Bid 26-27

Robert Crown Storage Room

ADDENDUM No. 1

This addendum forms part of the Request for Proposal Documents for Proposal #26-27 and modifies these documents. This addendum consists of the following:

COVER PAGE, GENERAL NOTES, MATERIAL SPECIFICATIONS

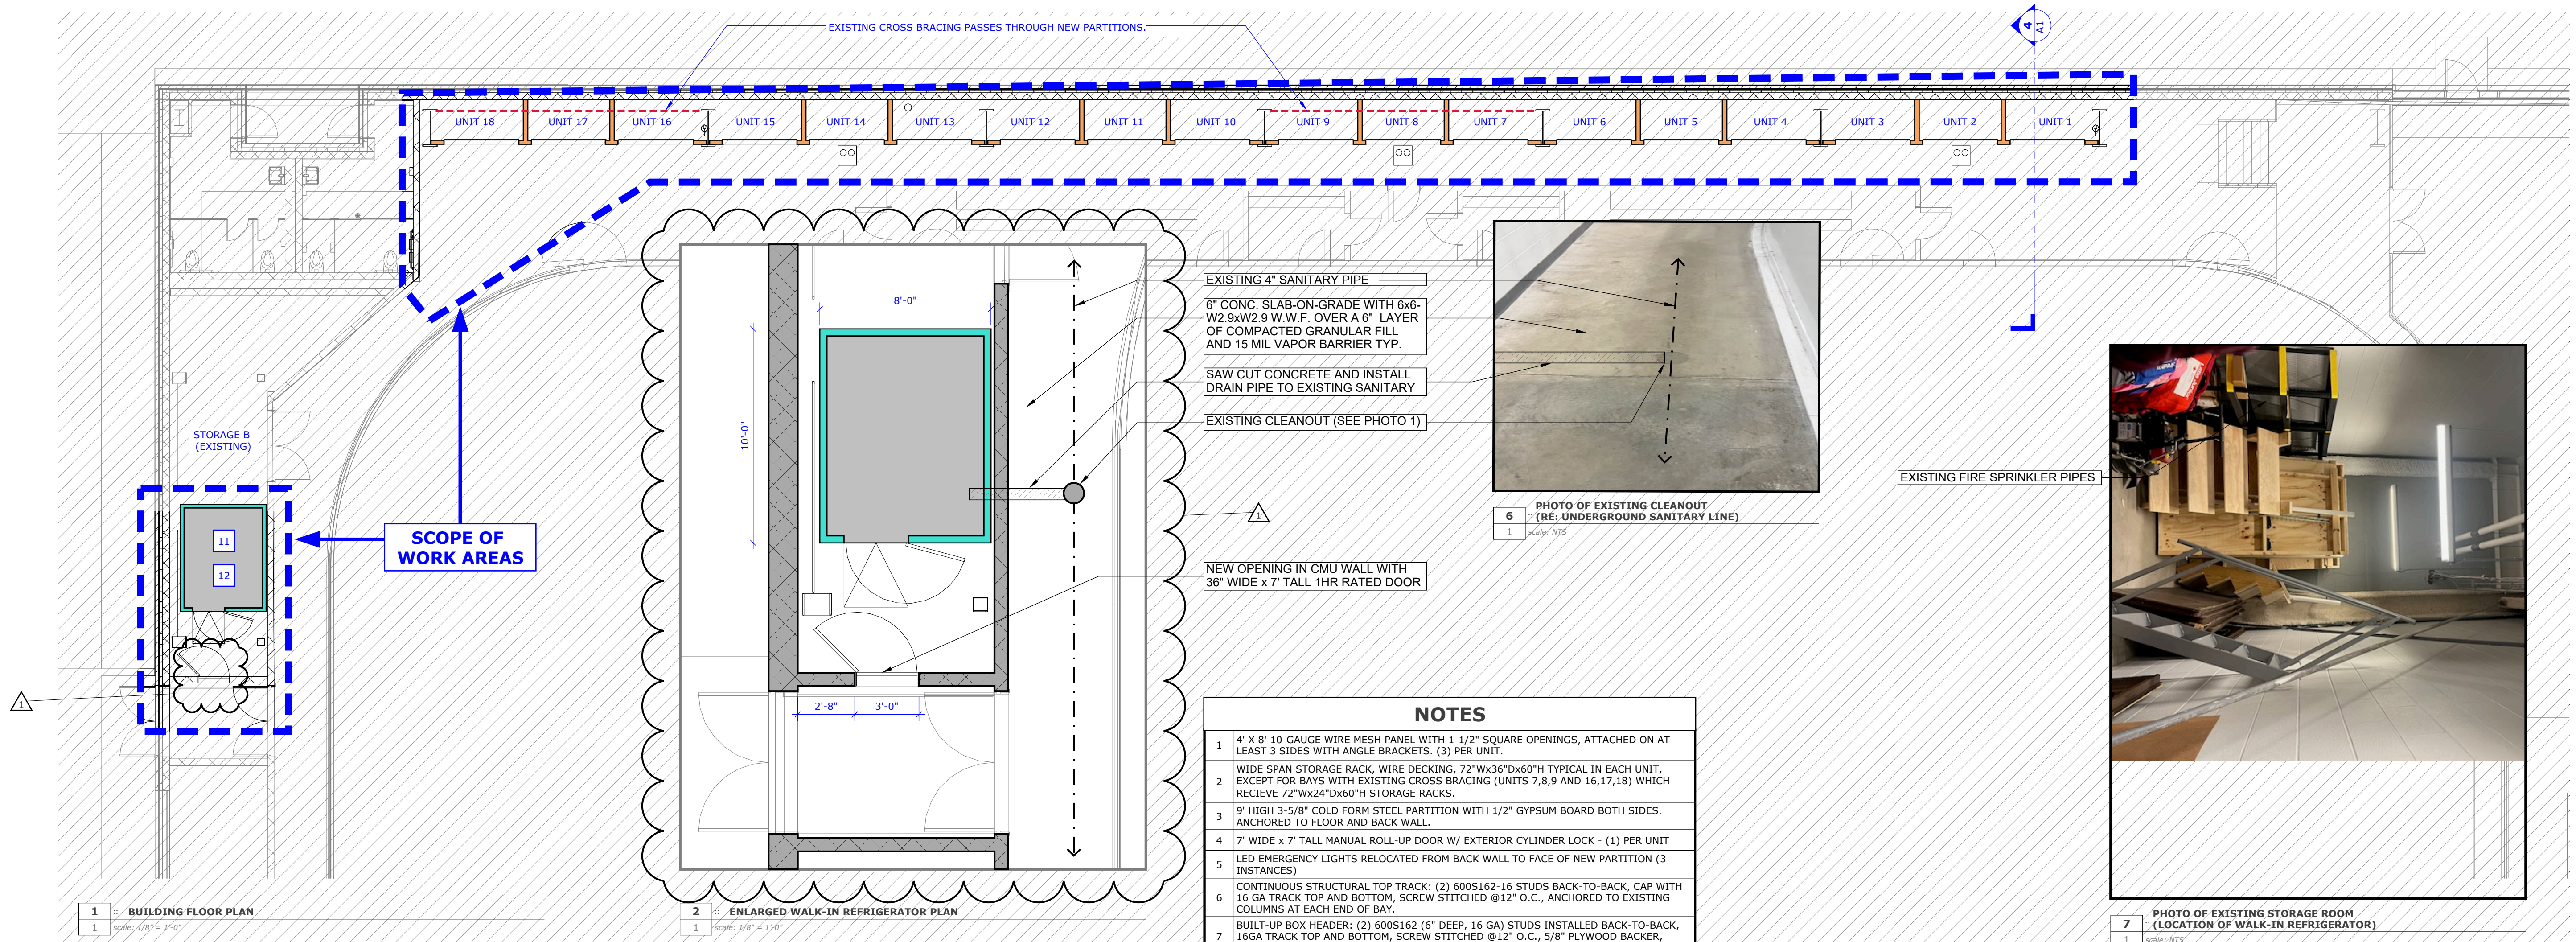
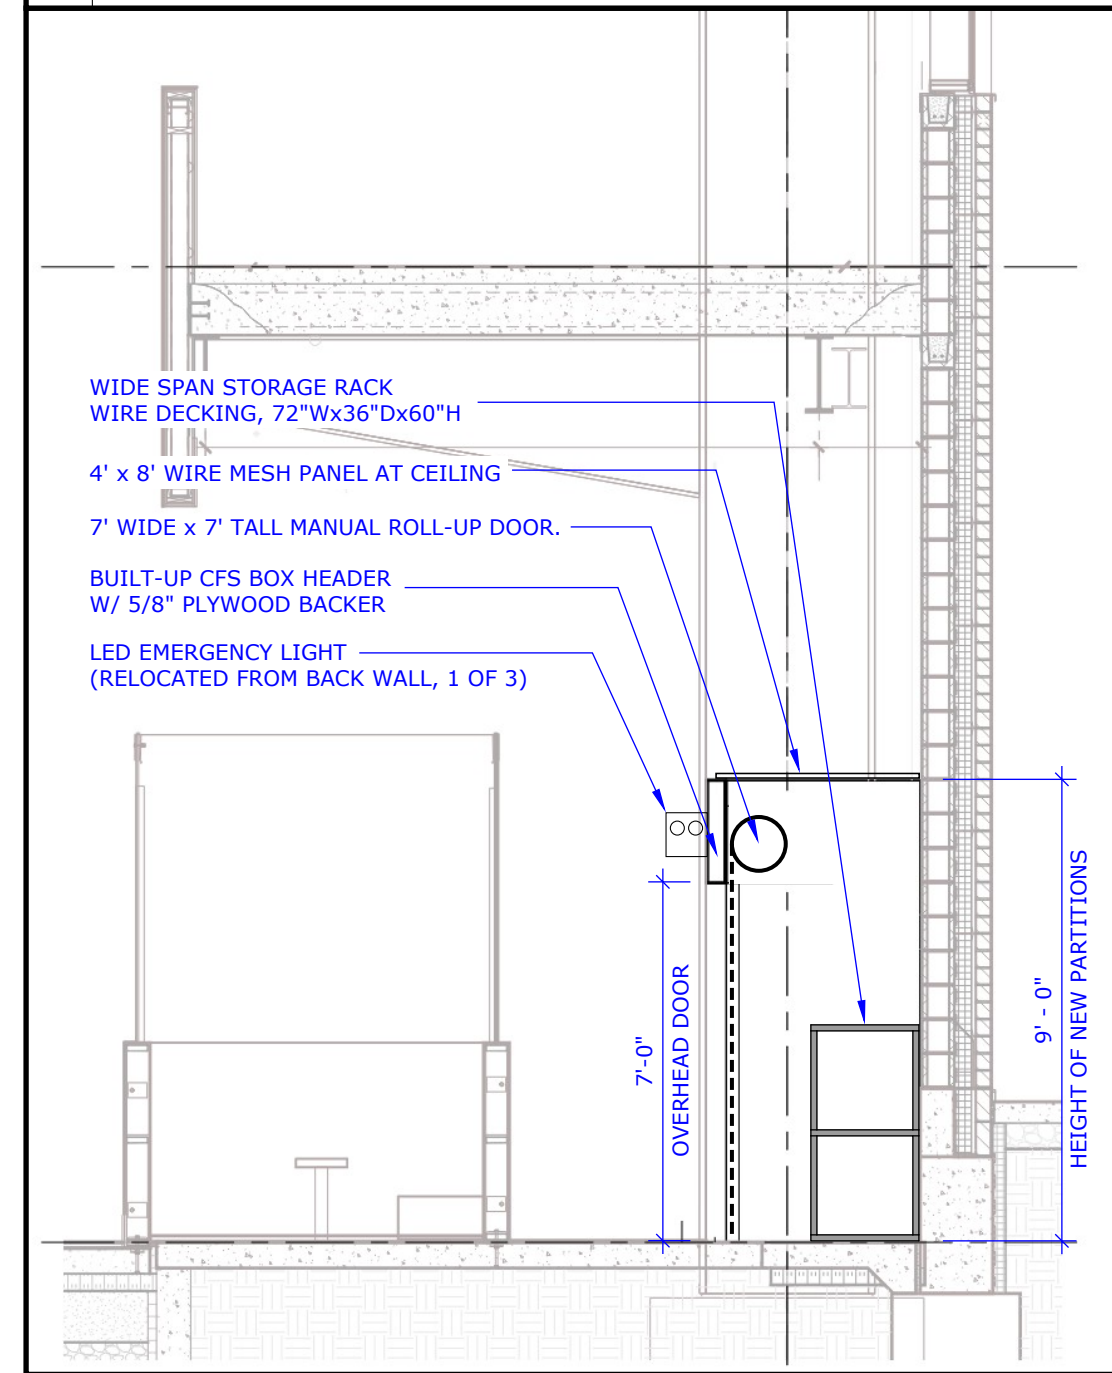
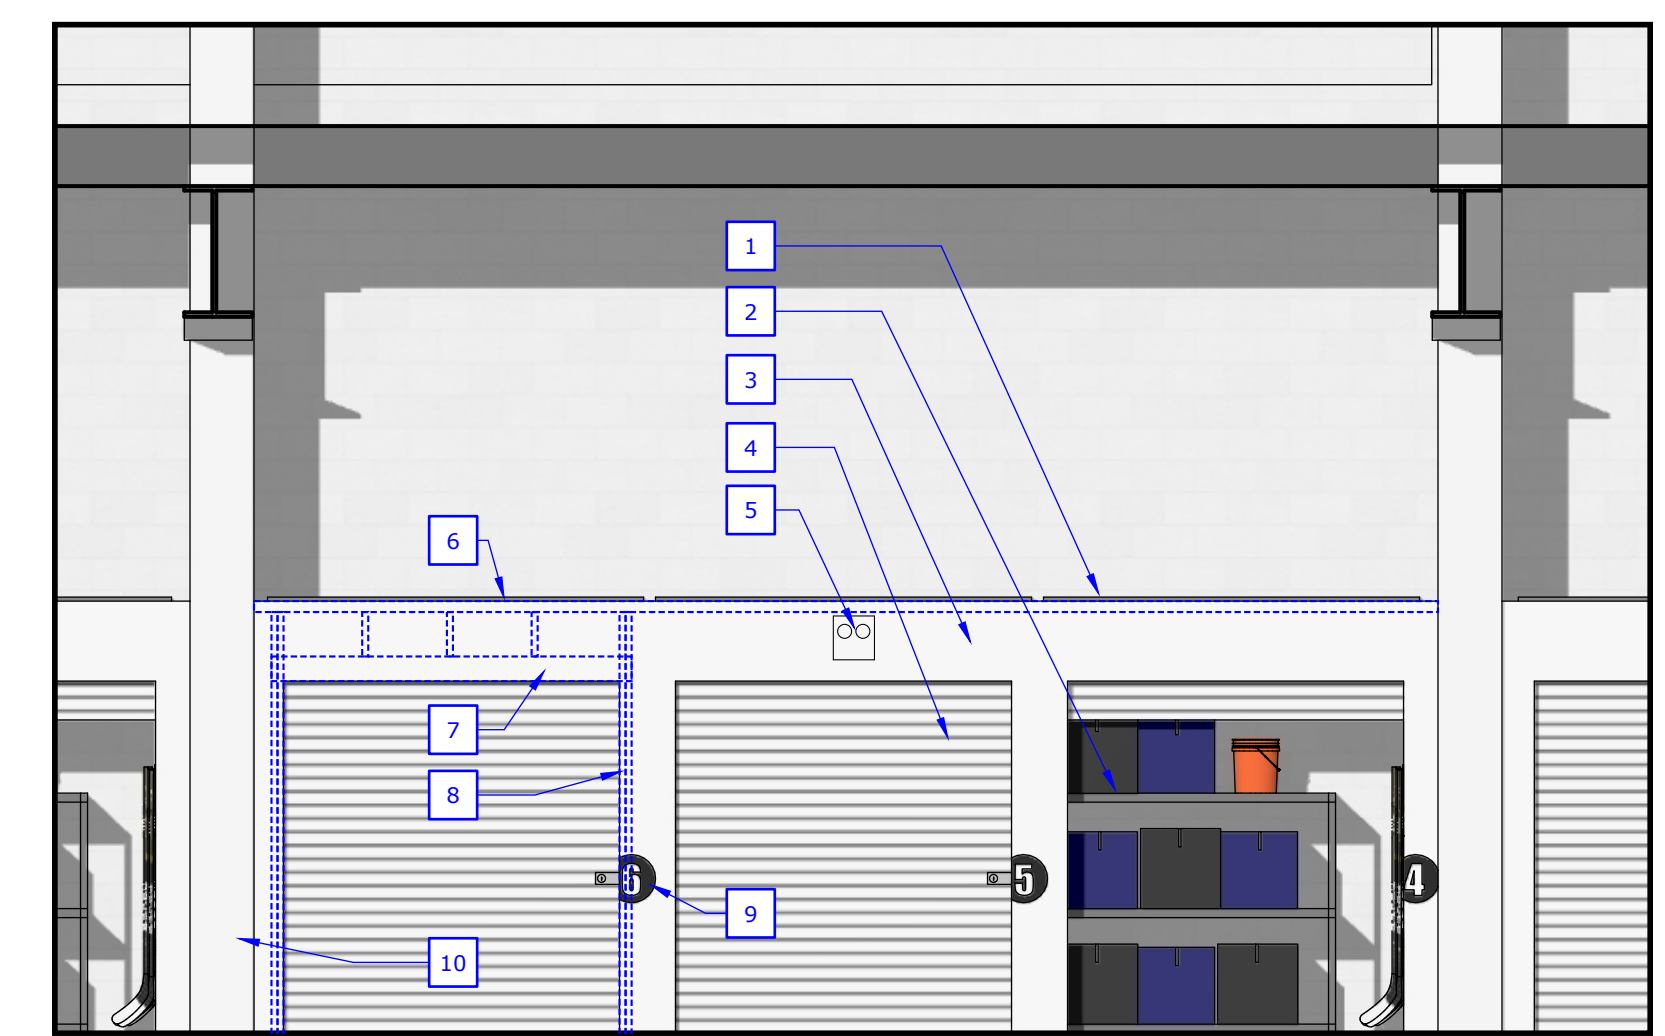
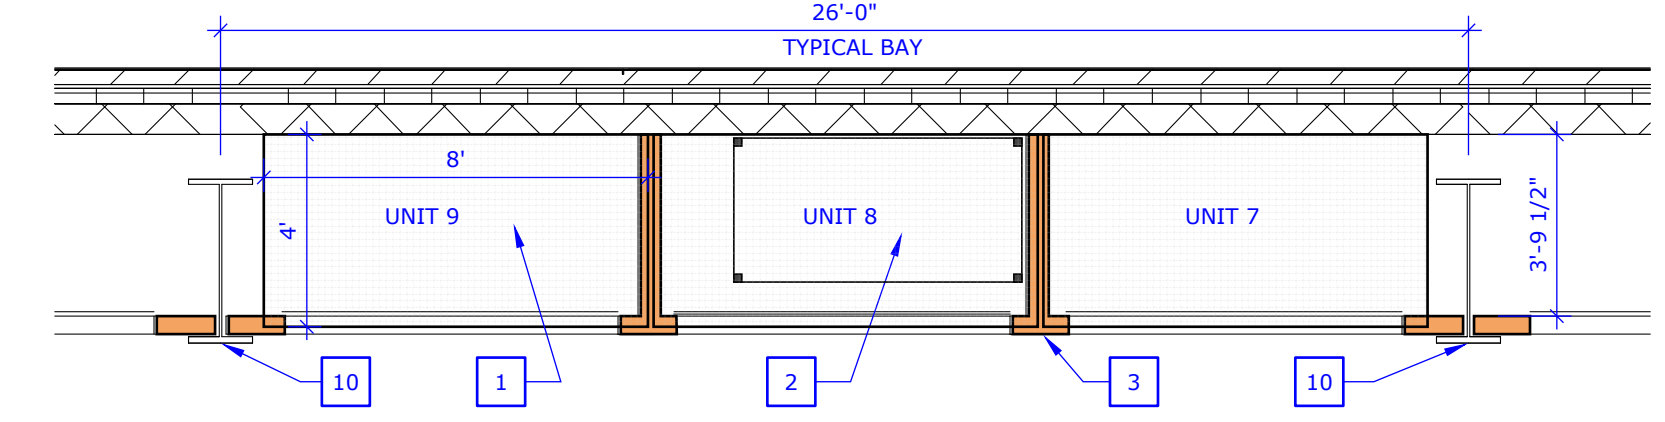
1. Updated Drawing set (Sheet A1) showing enlarged plan of room where walk-in refrigerator is to be located, clarifying that a new door is to be added in the existing CMU wall.
2. Electrical Plan of existing building provided to show location of nearest electrical panels, as it relates to providing power to the walk-in refrigerator.
3. Plumbing Plan of existing building provided to show location of nearest sanitary pipe, as it relates to providing drainage for condensate from walk-in refrigerator.
4. Site Plan of existing building provided to show location of construction dumpsters and material storage/staging.
5. Pre-bid meeting sign-in sheet
